December 27, 2022

ADDENDUM #2
QUOTE 22-131-3120
For: Mowing Services

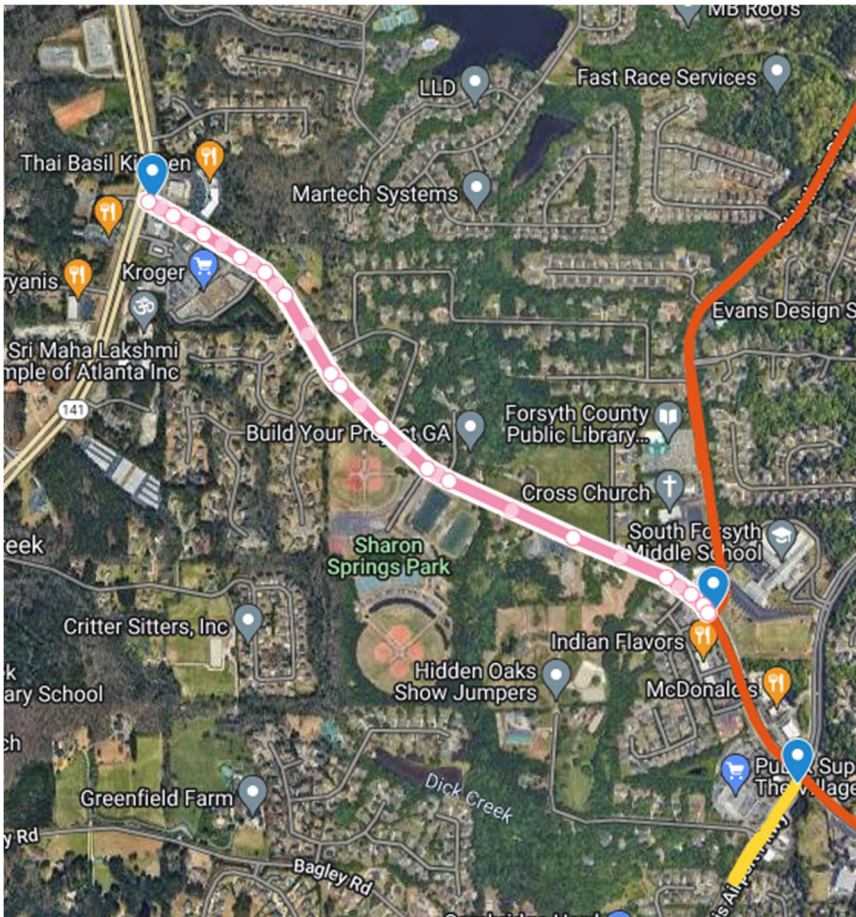
4. Should the contractor price for a six point program: 3 fertilizations, 3 pre-emergent, and post emergent during the fertilizations and pre-emergents?

Answer: Please price according to the Bid Package outlined under Section B. Fertilization and Pre-Emergent; Number 3 and 4.
